Subject: MHI's Response to US-APWR DCD RAI No. 297-2287 Revision 2

MHI's Response to US-APWR DCD RAI No. 297-2287 Revision 2

**US-APWR Design Certification
Mitsubishi Heavy Industries
Docket No. 52-021**

RAI NO.: NO. 297-2287 REVISION 2
SRP SECTION: 15 – INTRODUCTION – TRANSIENT AND ACCIDENT ANALYSES
APPLICATION SECTION: 15.0.0
DATE OF RAI ISSUE: 5/04/2009

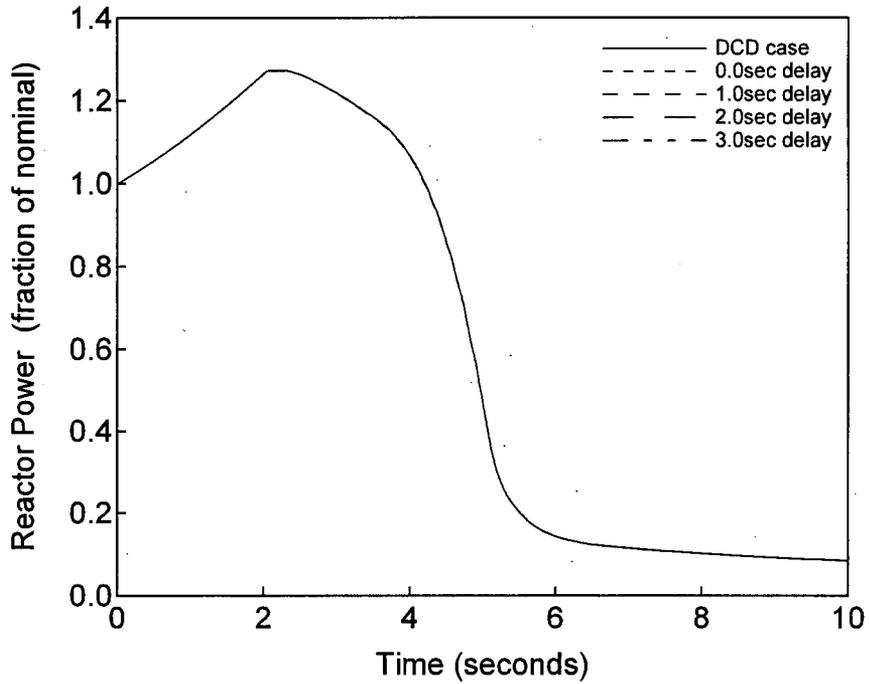
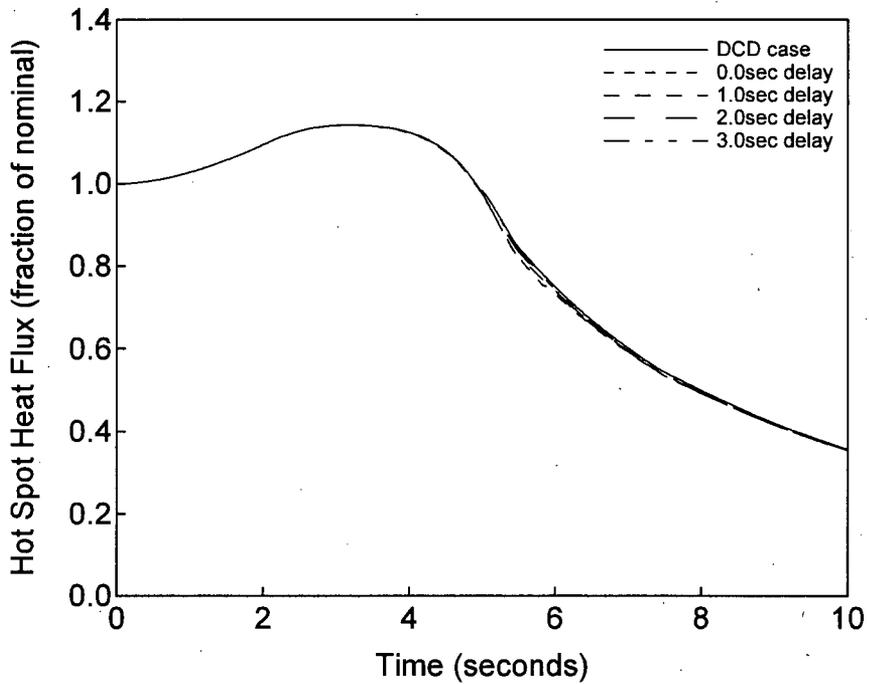
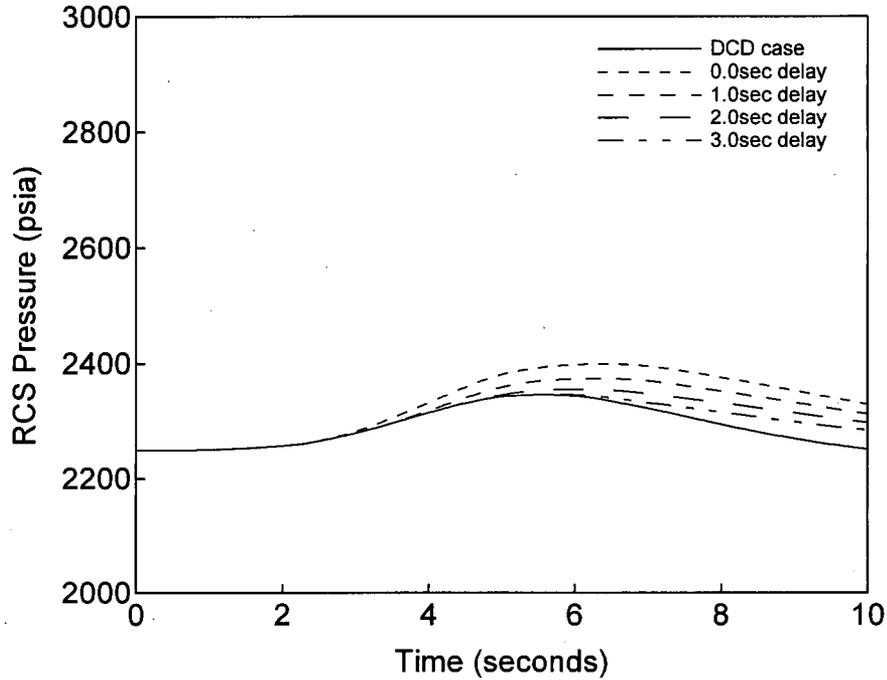
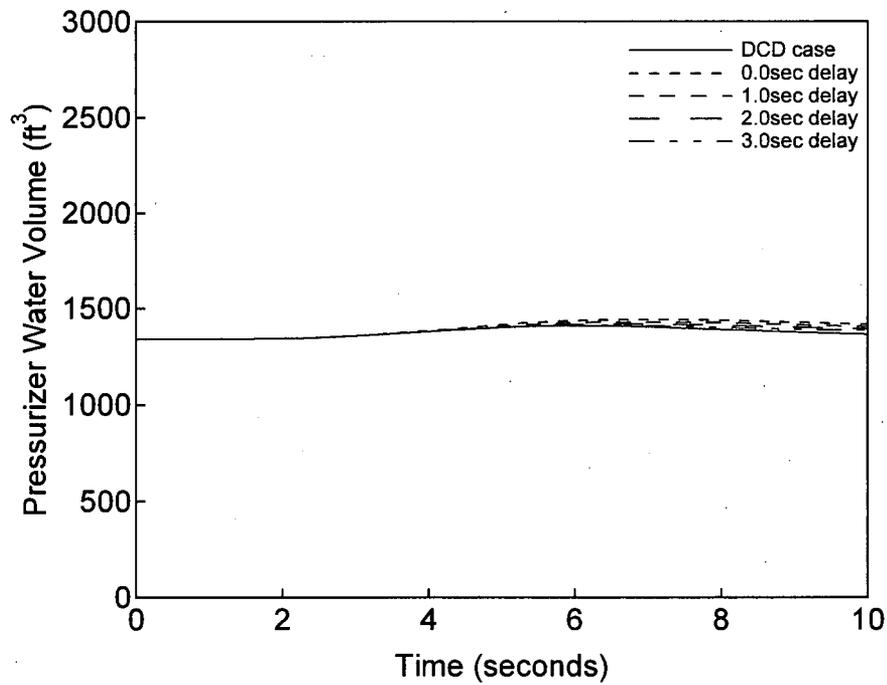
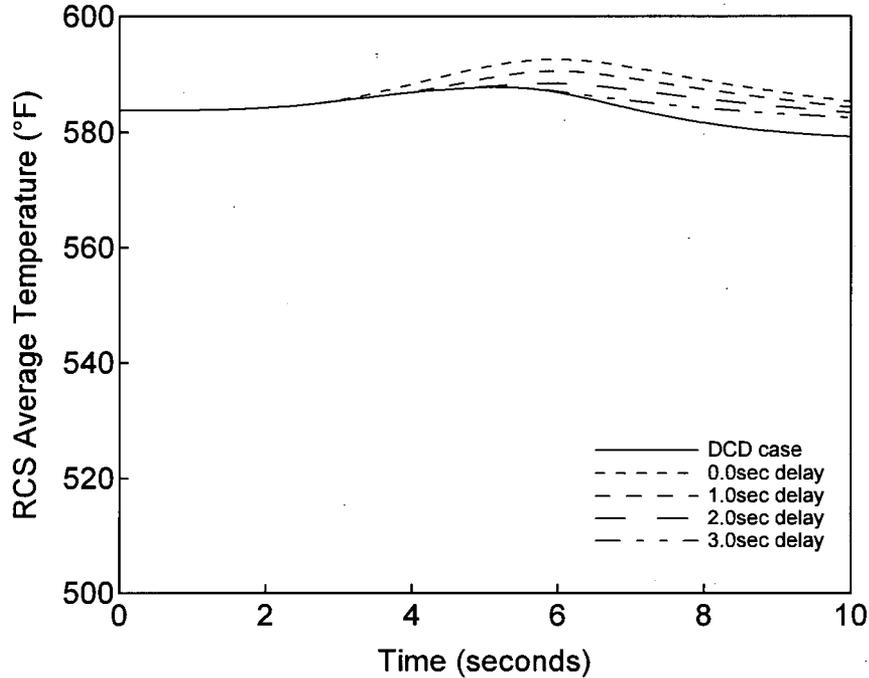
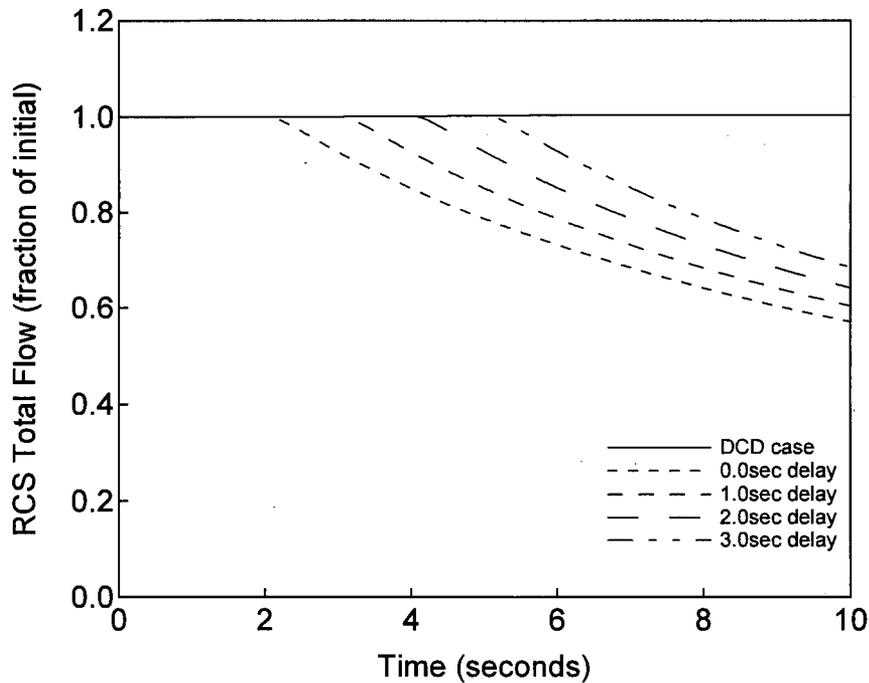
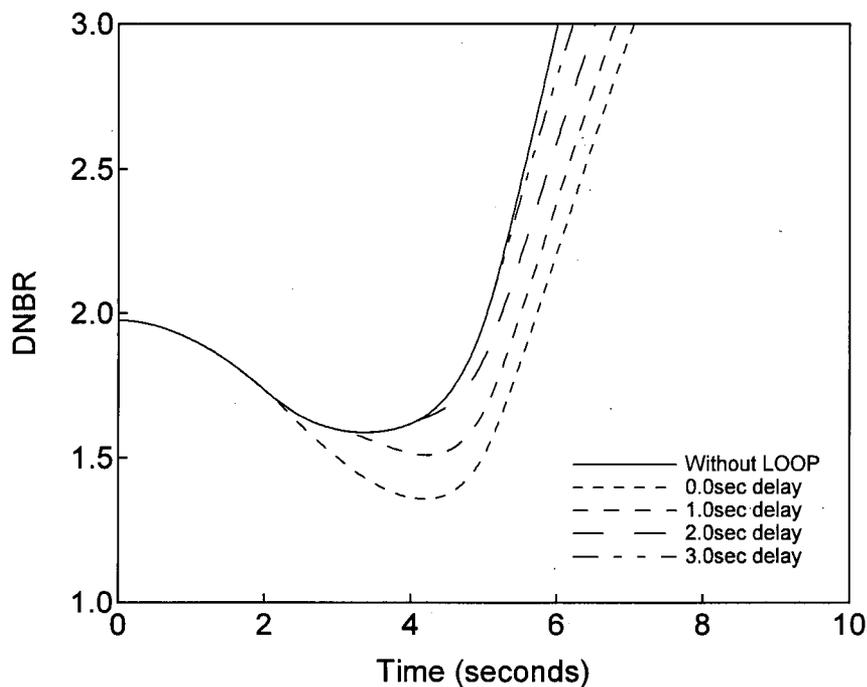
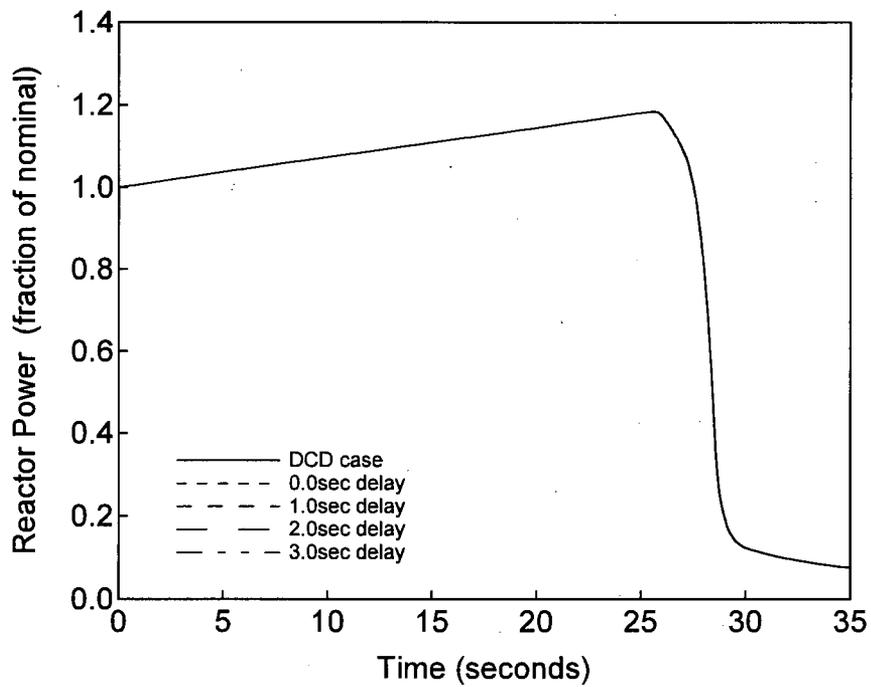
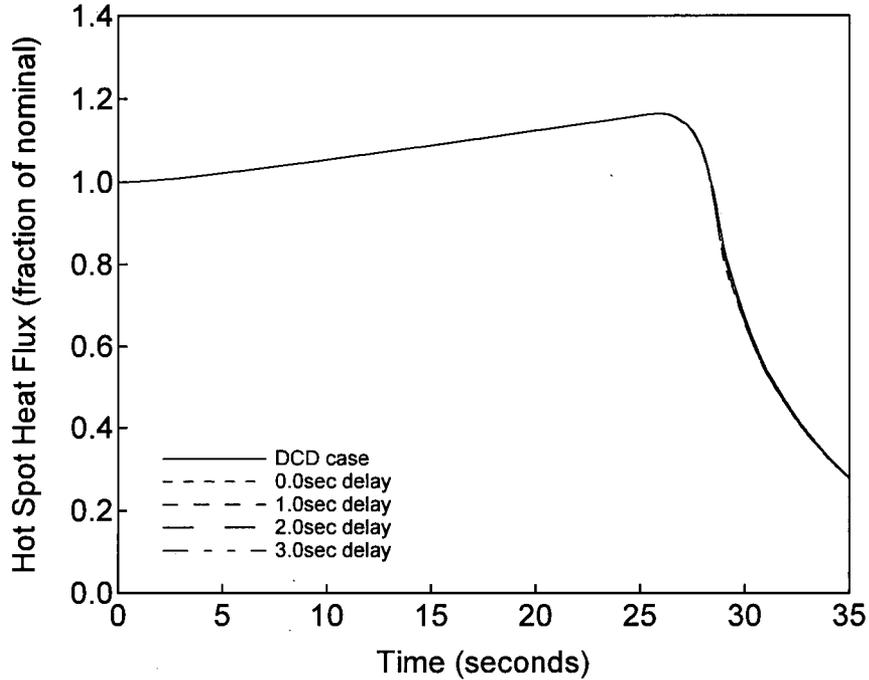
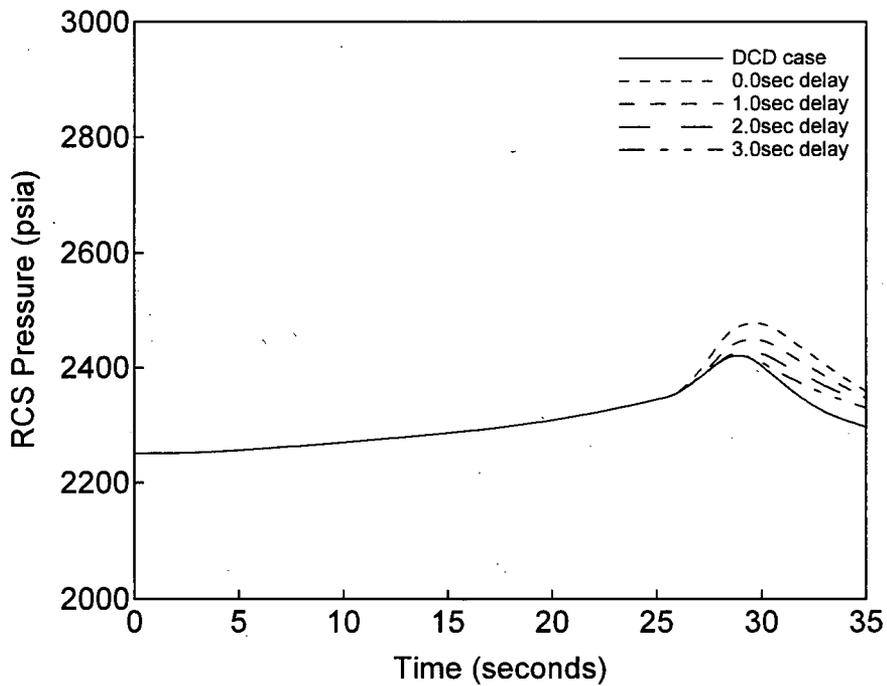
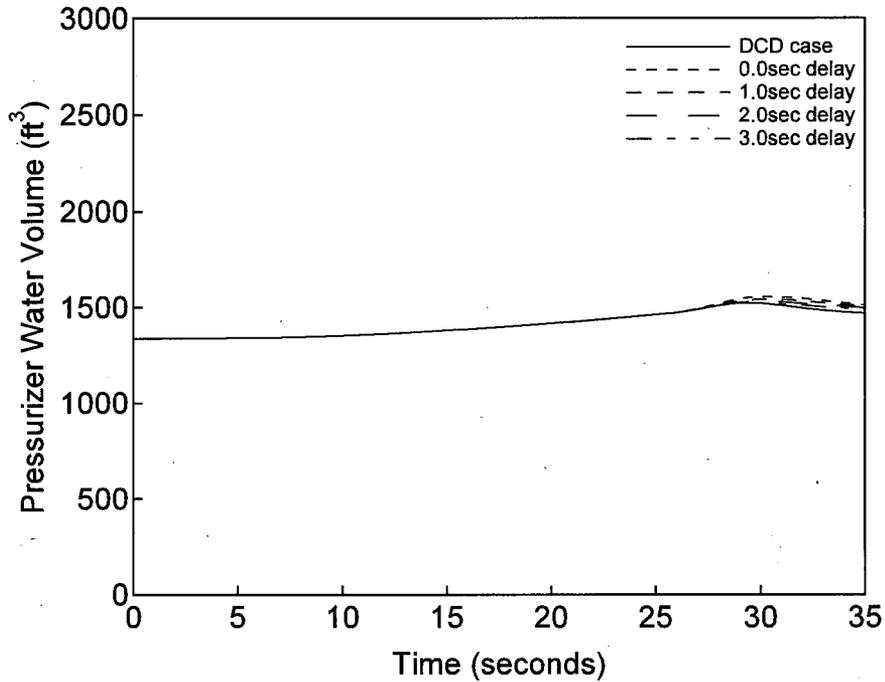
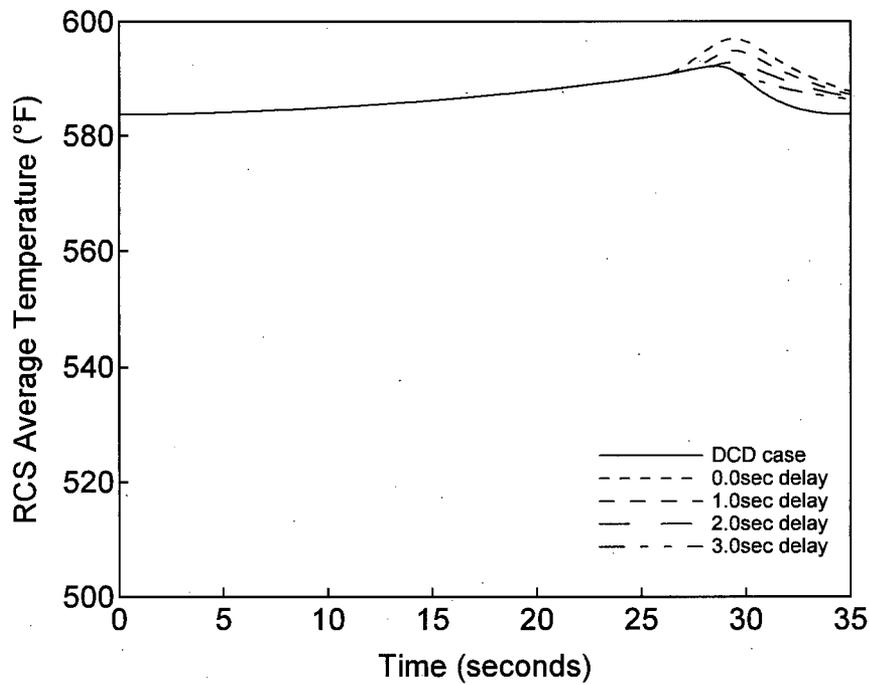
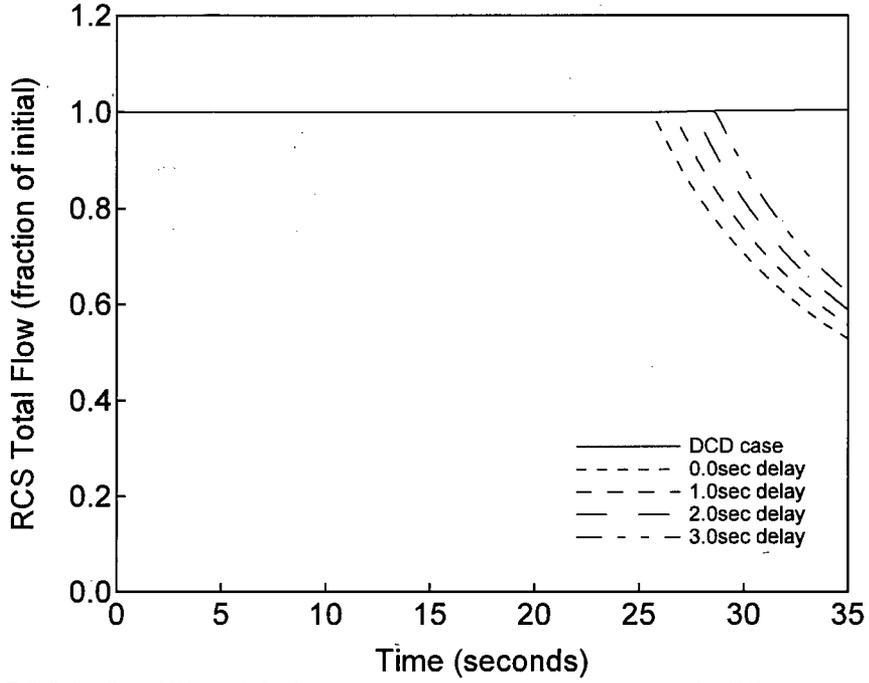
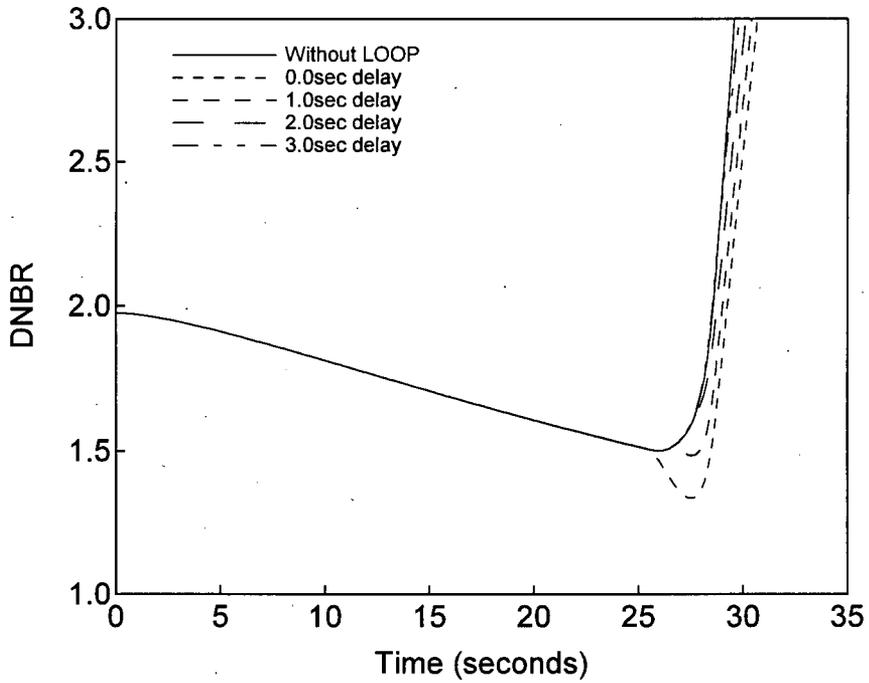
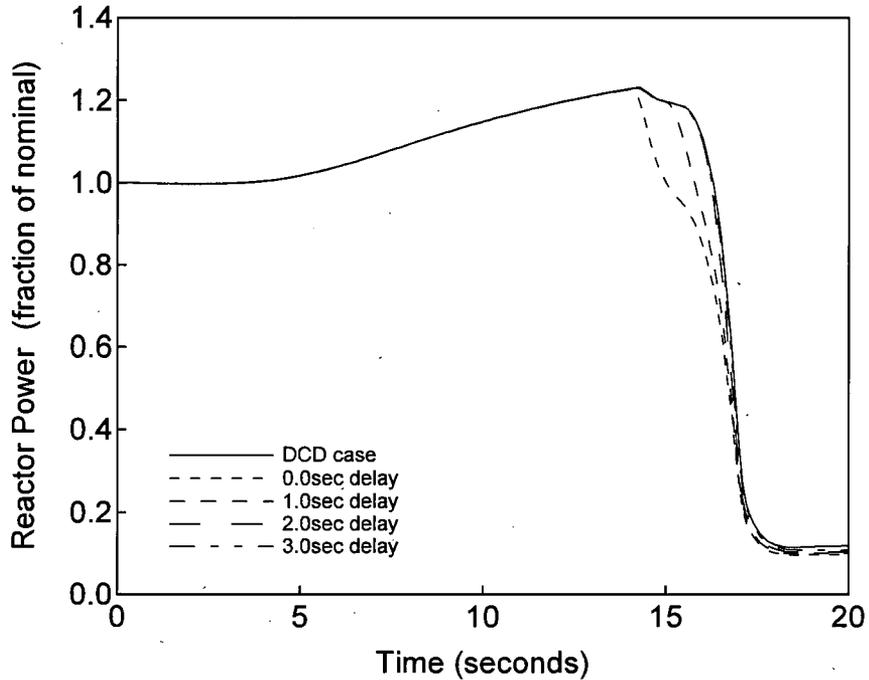
In DCD Section 15.0.0.7, the applicant presents arguments concerning the timing of a LOOP with respect to the timing of reactor trip and RCP coast down. By assuming a time delay in the onset of a LOOP, the onset of DNBR is decoupled from the availability of offsite power because the rods are inserted to the dashpot by the time the LOOP is initiated; therefore, the RCPs continue to run until the rods have been inserted in the core. This argument repeats itself throughout many Chapter 15 scenarios, allowing for the neglect of any LOOP consequences. Please provide more substantial arguments in defense of this assumed time delay, supported by sensitivity calculations that directly address this issue. (see also Question 15.1.2-1).

As described in DCD Subsection 15.0.0.7 and the response to Question 15.0.0-2 of this RAI, the US-APWR DCD Chapter 15 analyses currently assume a loss of offsite power (LOOP) occurs a minimum of 3 seconds after the reactor trip. This 3-second delay accounts for the time it would take for a grid instability caused by the turbine-generator trip due to the reactor trip to propagate through the grid to the plant offsite power source. A turbine-generator trip without a prior reactor trip is also assumed to ultimately cause a LOOP with the same 3-second delay time.

The results of the DNBR sensitivity analysis of these four events validate the assumption described in DCD Subsection 15.0.0.7 (and reiterated in event-specific subsections) that, with a 3 second delay between the turbine-generator trip and LOOP, the minimum DNBR is the same for the case with and without LOOP. The results of this sensitivity also show that there is some available margin in the delay time assumed since the minimum DNBR is the same for the case with LOOP assuming a 2 second delay and without LOOP. In addition, while the minimum DNBR for the 1 second delay cases were slightly worse than the cases without LOOP, the DNBR remained above the safety analysis analytical limit. Since the four events selected for this sensitivity analysis were representative DNBR events in Chapter 15, the remaining DNBR analysis in Chapter 15 would also be adequate even assuming a 1 second delay (excluding those events that already violated the DNBR limit, such as the RCP rotor seizure). Although the results showed that the two 0 second delay RWP cases result in a minimum DNBR below the acceptance limit, the US-APWR DCD contains COL Item 8.2(11) which requires that the COL applicant perform a grid stability analysis to confirm that the LOOP occurs at 3 seconds or greater. This is also described in the response to Question 15.0.0-4 of this RAI.
